ENGINE - FUEL AND CONTROL - POWER PLANT- EEC CHANNEL A AND B HARNESSSES (LOOM A AND B) -
ENGINE DEDICATED ALTERNATOR HARNESS CONNECTORS WITH IMPROVED LOCKING FEATURE -
CATEGORY CODE 4 - MOD.ENG-73-0092

V2500-ENG-73-0092

SERVICE BULLETIN

General view of engine
Fig.1

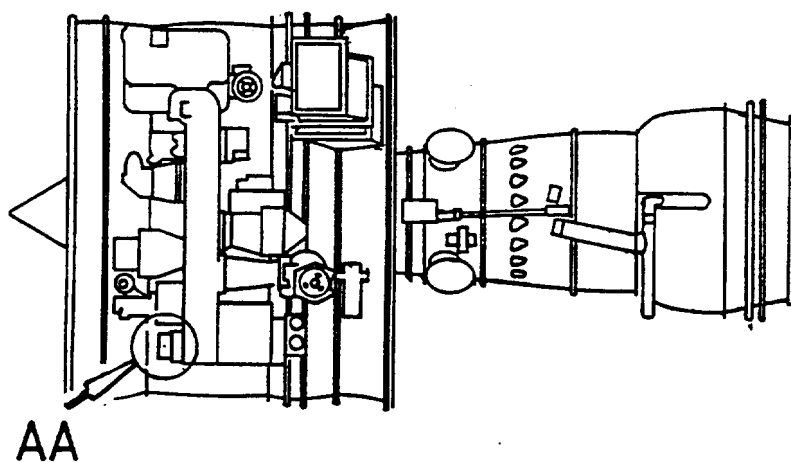
- (1) This Service Bulletin introduces back-to-back clipping fitted over the E.D.A. connector nuts P1-6017 and P1-6024 to overcome the possibility of the connectors unlocking.

- (a) Clip point 2684 is added to prevent the connector nuts unlocking.

E.D.A. connection - assembly of
Fig.2

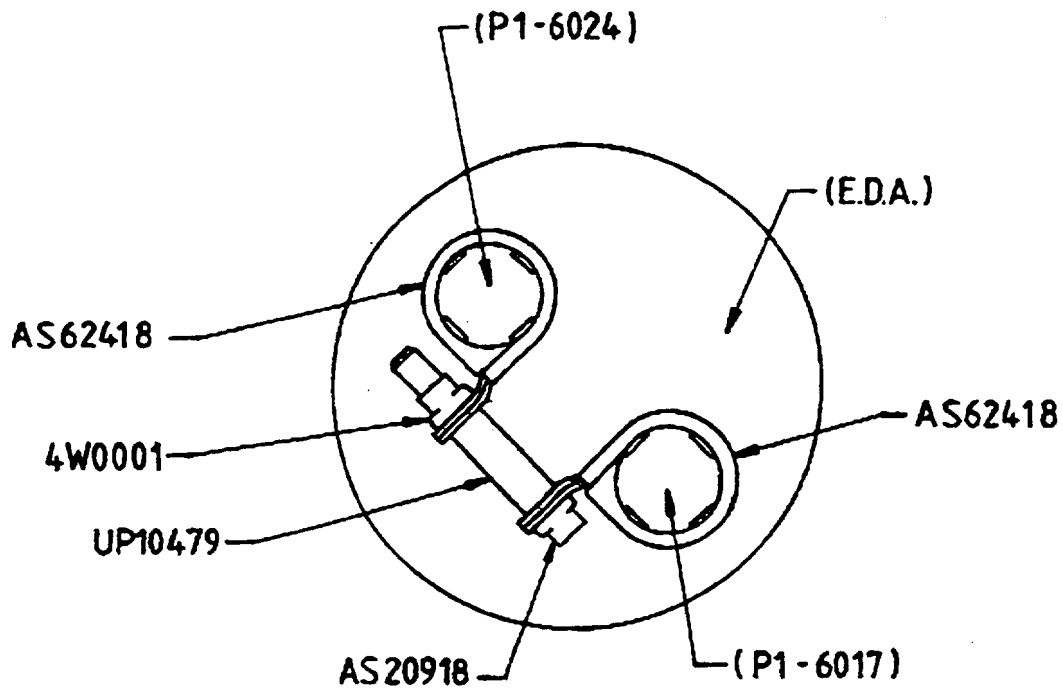
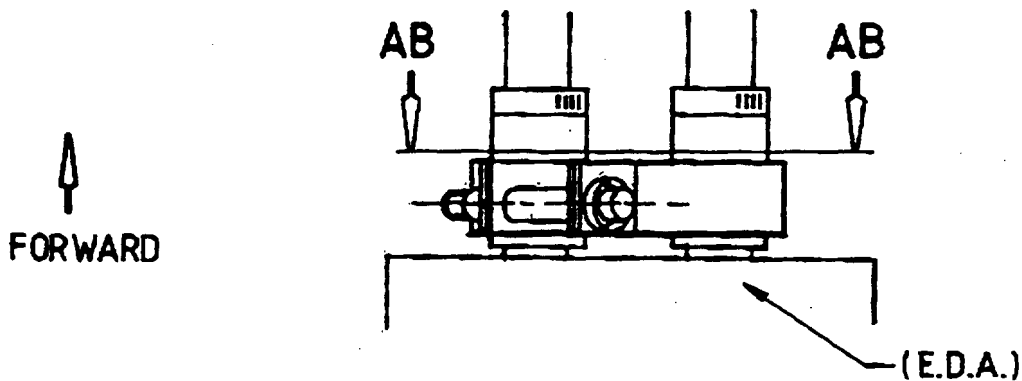
- (1) Use soft-jaw pliers to tighten the two connectors.
- (2) Use OMat 262, marker, to make a mark on the connector nut and backshell to show if the connectors are not locked.
- (3) Put the two clips in position over the connector backshells and assemble the clips, refer to Fig.2.
- (4) Make sure the connector coupling nuts are tight.
- (5) Push the two clips over the connector coupling nuts and tighten the nut (4W0001), refer to Fig.3.
- (6) Make sure the clips are positioned correctly, then torque the clip nut (4W0001).
